Service Bulletin

Bulletin No.: PI0522D

Subject: Tick, Buzz or Rattle Noise from Front of Dash, Transmission Filler Tube Cracked or Broken

Models: 2007-2013 Cadillac Escalade Models (excluding Hybrids)
2007-2013 Chevrolet Avalanche, Silverado, Suburban, Tahoe (excluding Hybrids)
2007-2013 GMC Sierra, Yukon Models (excluding Hybrids)

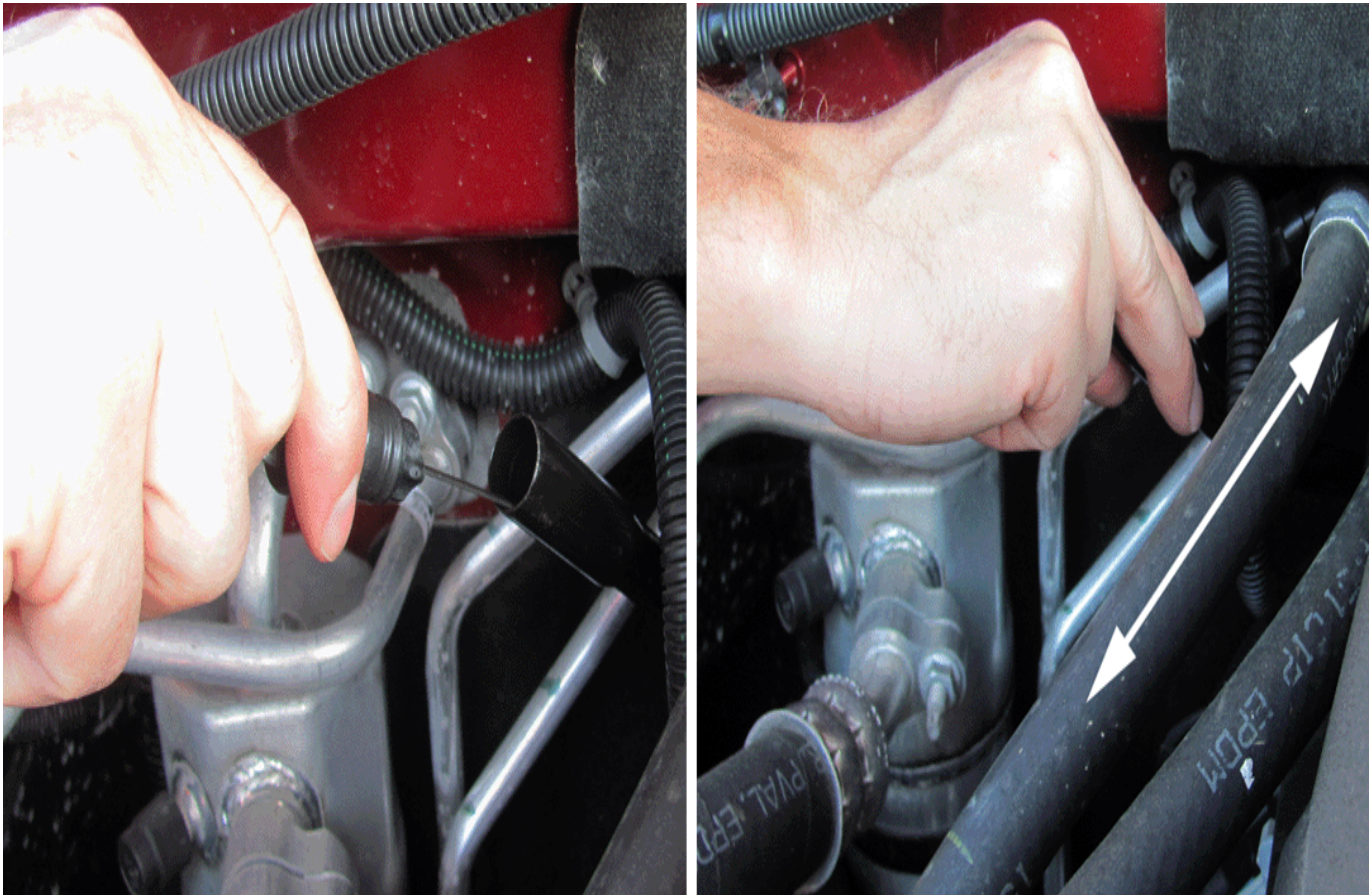
Some customers may comment on a rattle, buzz, tick, or vibration type noise that appears to be coming from the center of the dash. Root cause may be the transmission dipstick tube contacting the front of dash (cowl). If the transmission dipstick tube is too far rearward, it will contact the front of dash and vibrate, buzz, etc., causing the noise to sound like it is inside the dash area.

To correct this concern adjust/bend the transmission dipstick tube away from the front of dash/cowl to provide additional clearance. When inspecting or adjusting the transmission dipstick tube, it may appear to have enough clearance with the vehicle stopped. Verify that there is enough clearance to allow for powertrain movement during acceleration and deceleration. Inspect for contact while shifting between Drive and Reverse.

2906255

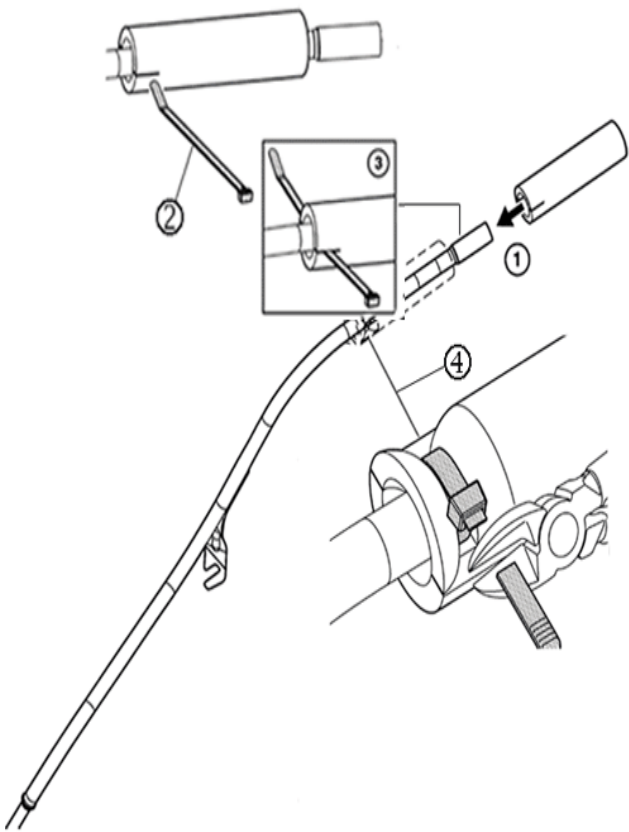
3. Grasp the transmission filler tube with your thumb and first two fingers of your right hand. Your thumb should be on the passenger side of the transmission filler tube and parallel to the filler tube.

4. Using only your thumb and the first two fingers of your right hand, force the transmission filler tube toward the driver's seating position and then back to the passenger's front wheel two times.

5. Determine if the transmission filler tube is damaged. An undamaged transmission filler tube will move less than two inches and spring back to its original position, while a damaged transmission filler tube will move greater than two inches and will not spring back to its original position. A damaged transmission filler tube will likely crack during this inspection.

- If the transmission filler tube is not damaged, proceed to Step 6.
 - If the transmission filler tube is damaged, replace the transmission filler tube. Refer to Transmission Fluid Filler Tube and Seal Replacement in SI.
